Inspection Experience and Welding Guidance for Alloy 600 Welds and Overlays

NRC/PDI Meeting – May 2007

Fig. 1 Acceptance Examination Volume and Thickness Definitions

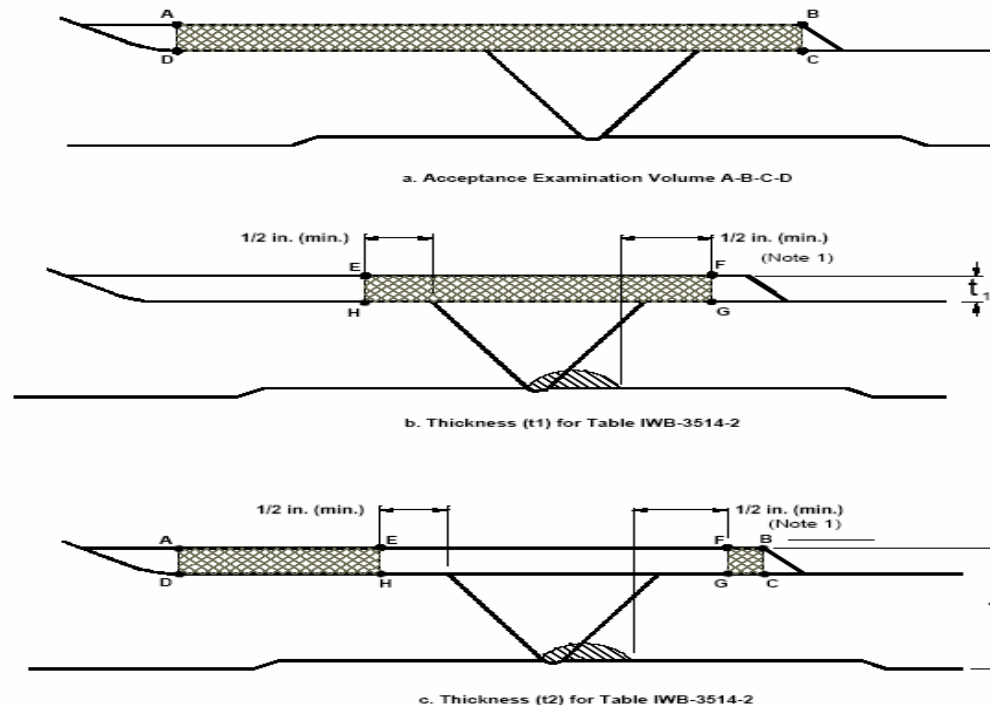
- The acceptance criteria in the proposed CC-740-1 have been revised to address several items
 - Any laminar flaw >3.0” shall be rejected (Too aggressive)

- Did not take into account size of overlay
 - Did not take into account that it may not be affecting the examination
 - Words still need to be changed
 - Remove reference to nominal pipe diameter

- Reduction of coverage calculations should be calculated for the ISI volume (Figure 2) not the PSI volume (Figure 1a)
 - The ISI volume is the most critical volume and should be the one used for this calculation since this is the volume that will be inspected in the future

Fig. 2
Preservice and Inservice Examination Volume

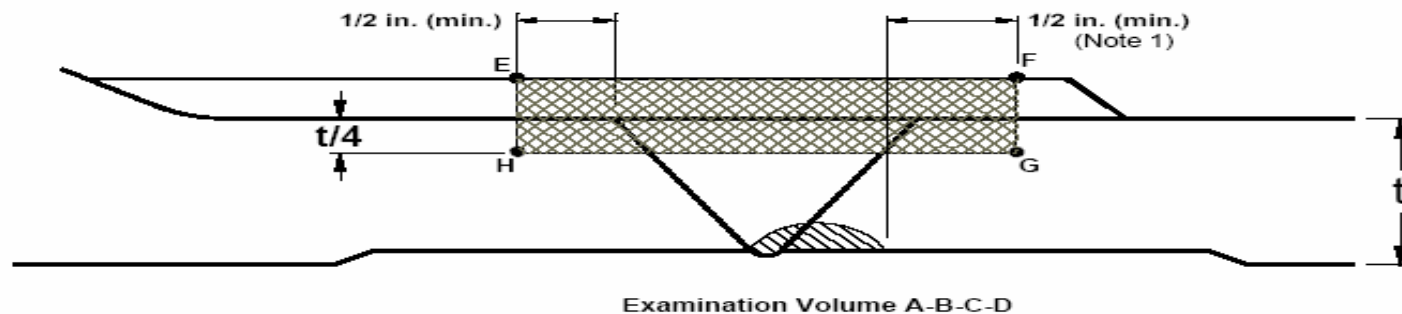
- Consideration should be placed on location of the flaw when performing acceptance calculations
 - Flaws on the edge of overlay outside of the ISI examination volume should be evaluated to the inservice rules
